Question on Coupler Wake

Kiyoshi Kubo

20080916

“The kick per period after the different number of periods”

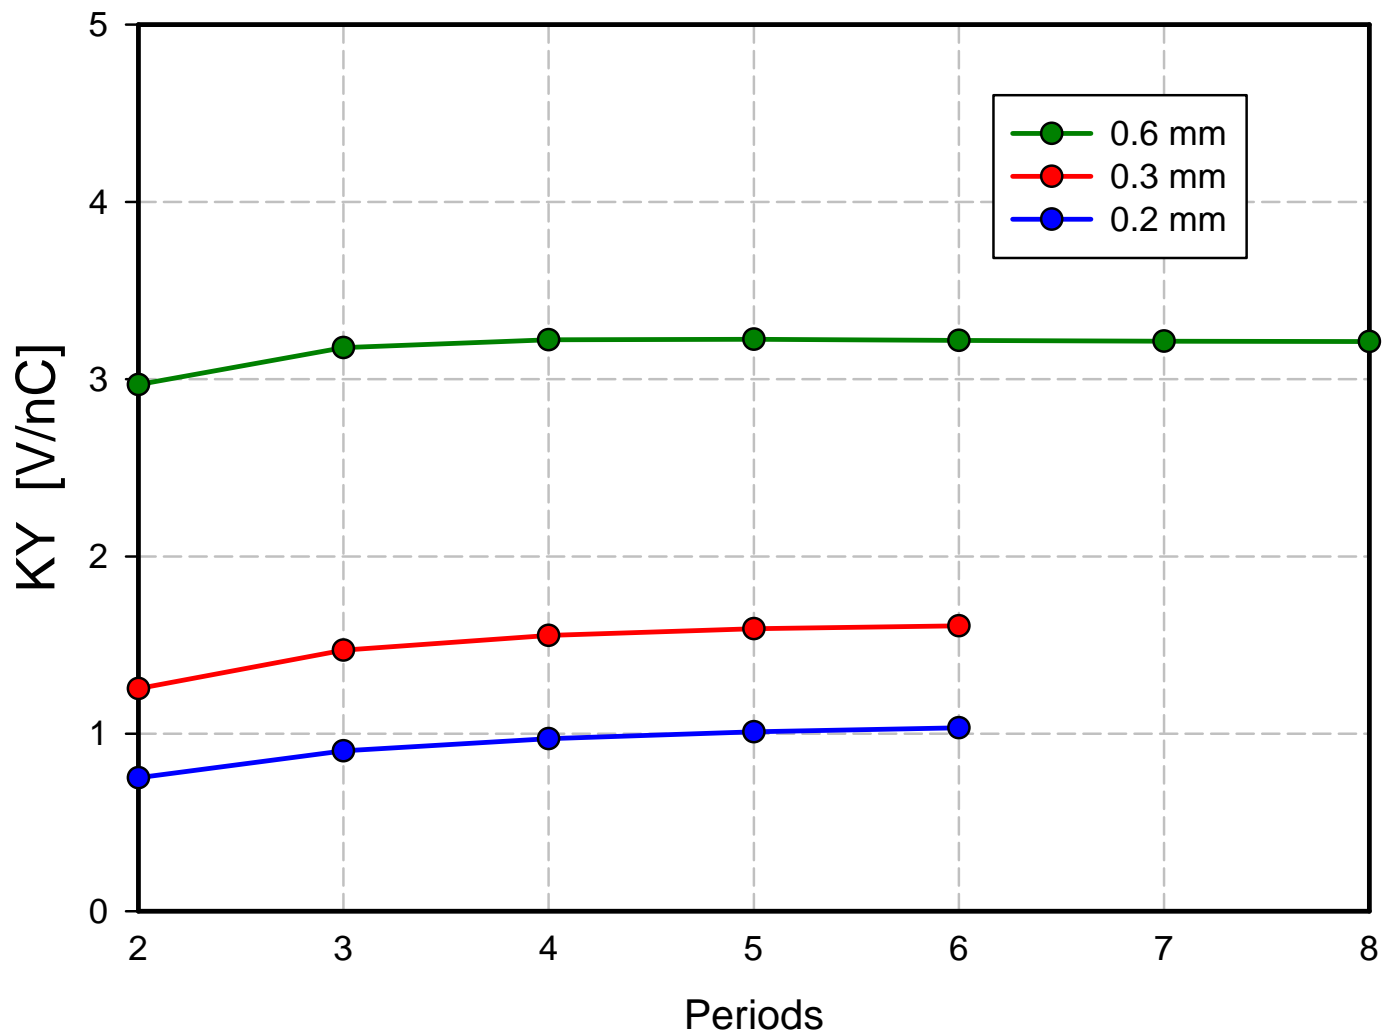
“Actual coupler wakepotential for short bunch beam (0.3 mm) is much smaller than that used to be estimated” is the conclusion?

→ Coupler wake will not a problem in main linac.

Correct?

How about in bunch compressors, where the bunch is not so short?
